Hi-Fi Products  
Service Bulletin

**Model:** STR-VX550

**No. 3**

**Subject:** Missing 1S1555 Diode

DISPLAY BOARD

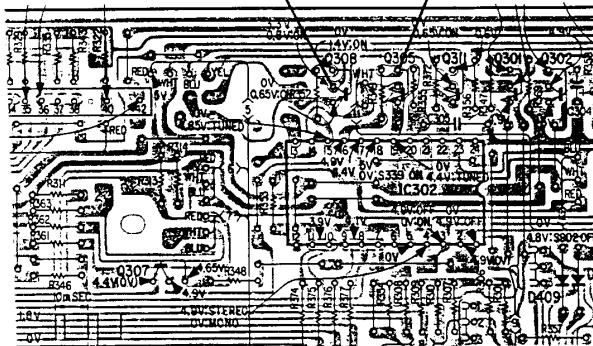
Early production of STR-VX550 diode 1S1555 was omitted from the display board.

When servicing STR-VX550, check if this diode is installed. If the diode is missing, solder a 1S1555 between collector of Q308 and base of Q305. The cathode should be connected to the collector of Q308.

Add Diode 1S1555  
Part No. 8-719-815-55
